**MUNICIPAL CORPORATION
KARACHI.**

Reference No. B. S. P. 866/40.

Case No. LCP 366/40 for building on plot
No. 79 S. S. 5 Old Quarter.
4 Jan

Re:- Plot No 79 O.T.4 Old Town Qr.

PLAN SHOWING THE PROPOSED BUILDING ON PLOT NO 79 O.T.4 OLD TOWN QUARTER SCALE 8" TO 1" INCH.

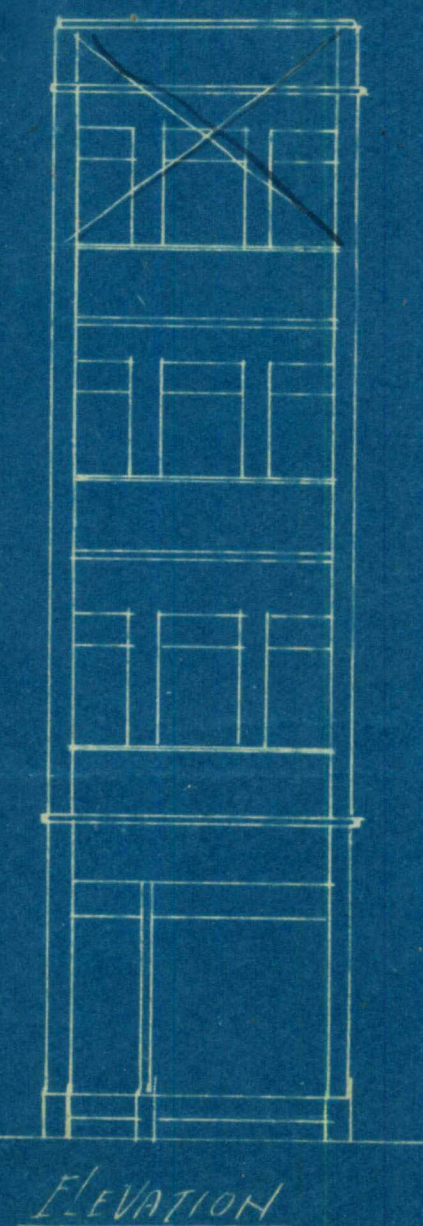
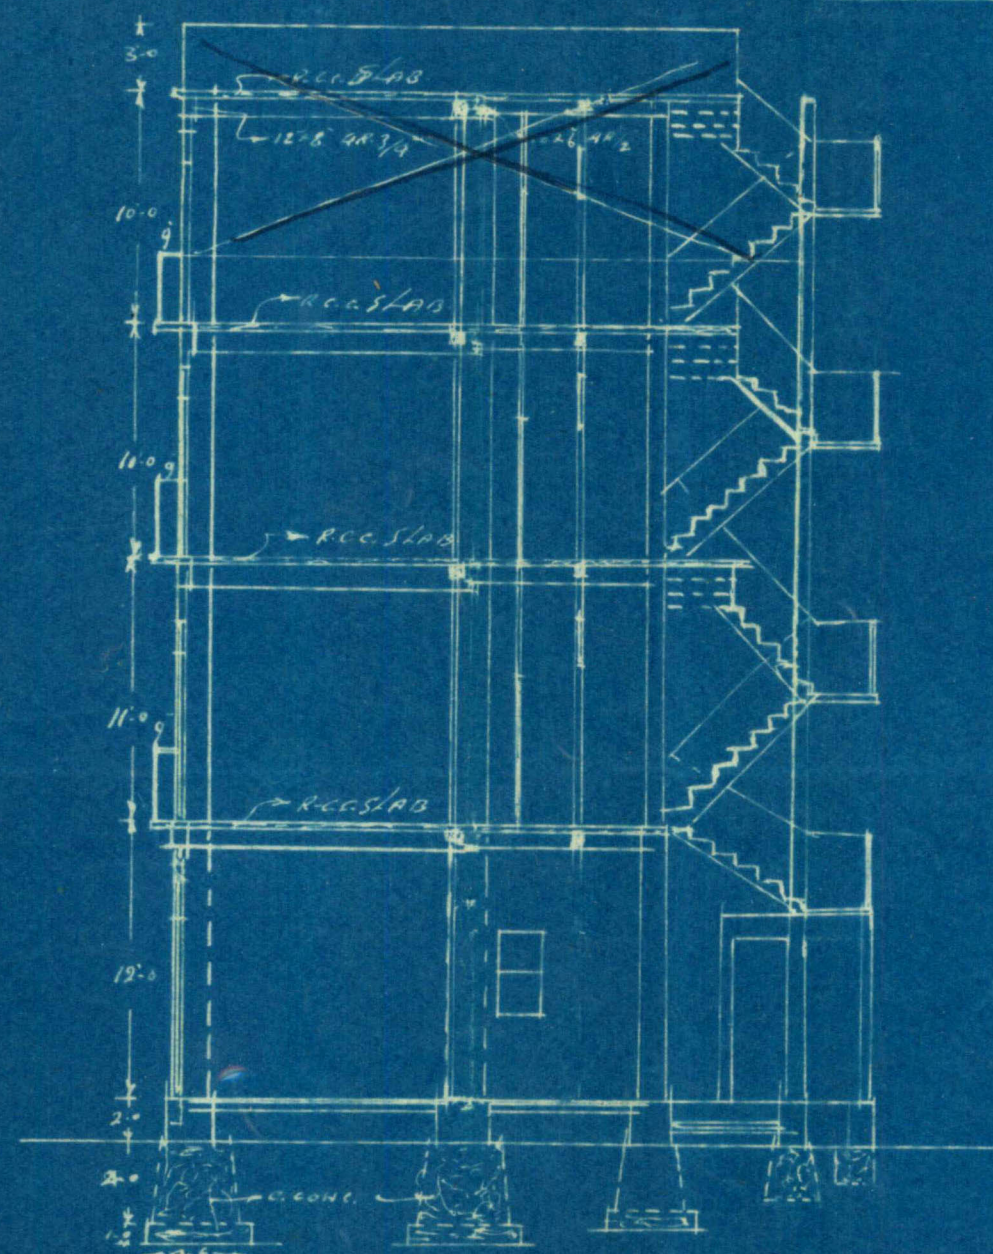
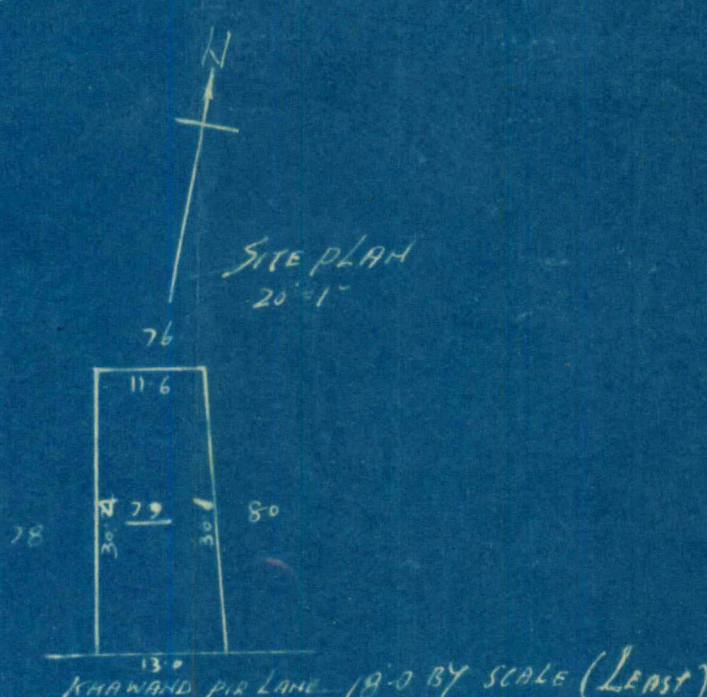
Objections No. 4, 5, 6, 8 of L.C.P. 366/40
dated 3-9-40 remain to be
complied with.

Please ask the architect to
send the plans with corrections
made by H.O, A.E + L.S. Dept.
so that clear plan may be
available for reviewing, as the
present copies are full of correction.

With reference to your letter No LCP.366/40 dated 3rd, Sept. 40. I am sending you herewith the plans complied with your objections as under:-

- 1 & 2. Complied with. The Kitchen platform is provided.
3. There are Bath & W.C. proposed below the staircase. Since the staircase is to be of R.C.C., I hope there will be no objection to the same.

4. The W.C. has been shifted.
- 5 to 8 Complied with.

11. The plans have been signed as also the "A" Form.
12. As the staircase is of R.C.C. there should be no objection to the W.C. below the staircase. However the papers may kindly be sent to the Chief Officer for his usual approval.
13. Complied with.
14. The passage has been increased.
15. Complied with.

PLAN SHOWING THE PROPOSED BUILDING ON PLOT NO 79 O.T.4 OLD TOWN QUARTER
SCALE 8 IN TO AN INCH.

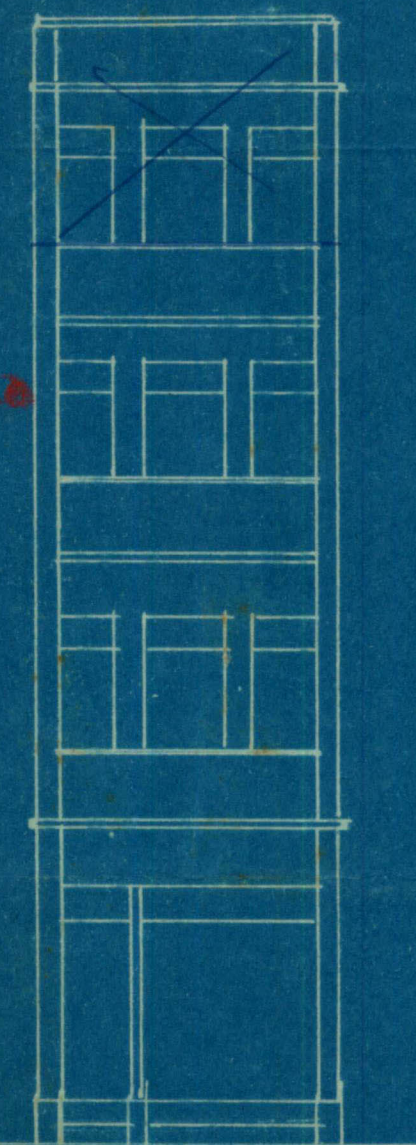
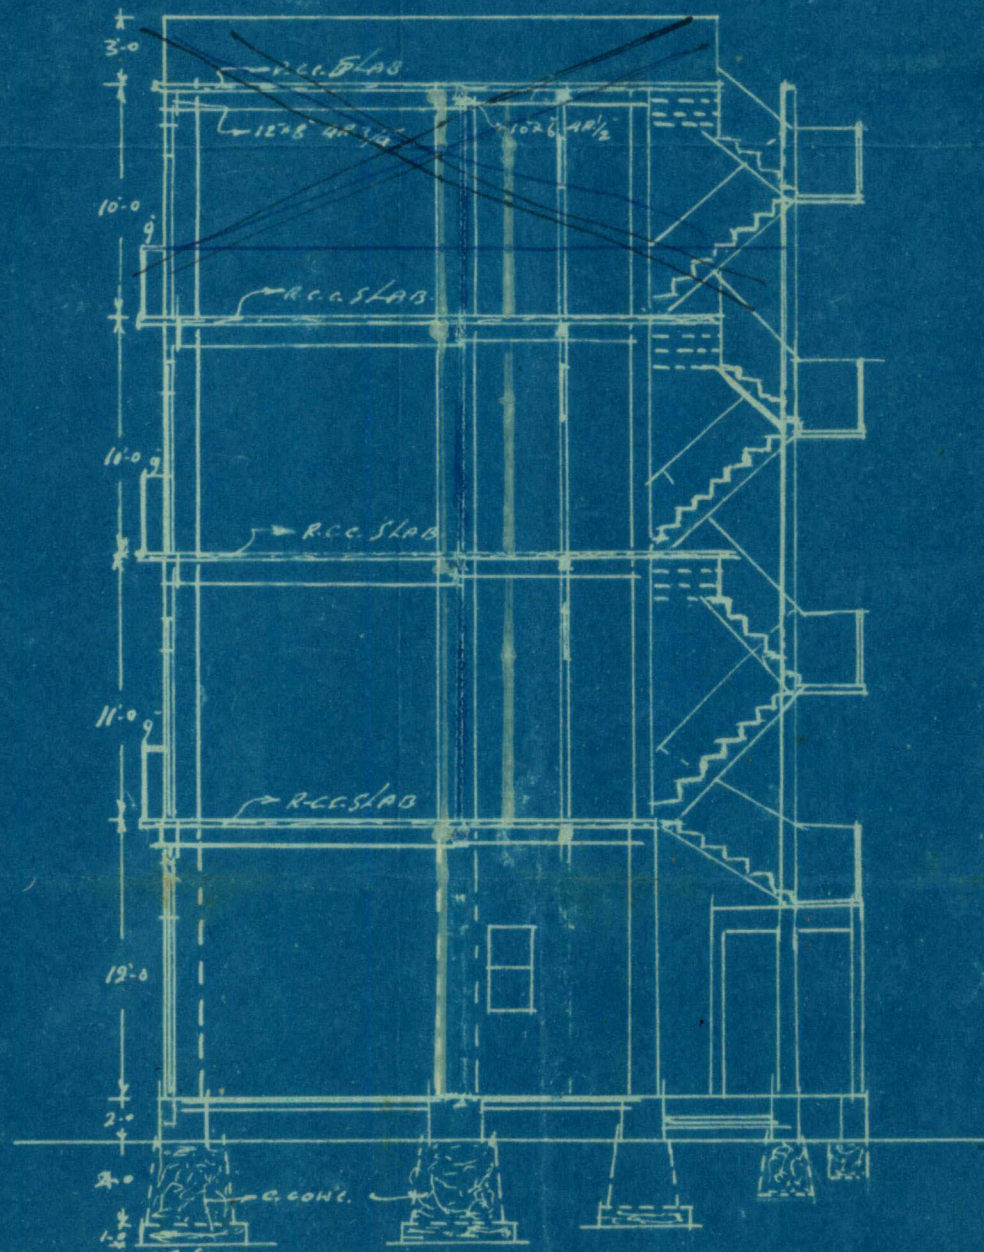
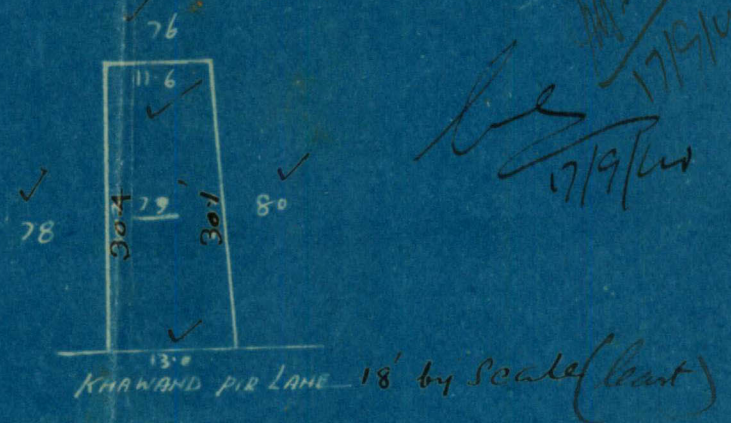
No objection as per
 correction as shown
 on the plan & bearing
 my initials ~~beaver~~
 dated 23-8-40.

All objections are
 complied with.
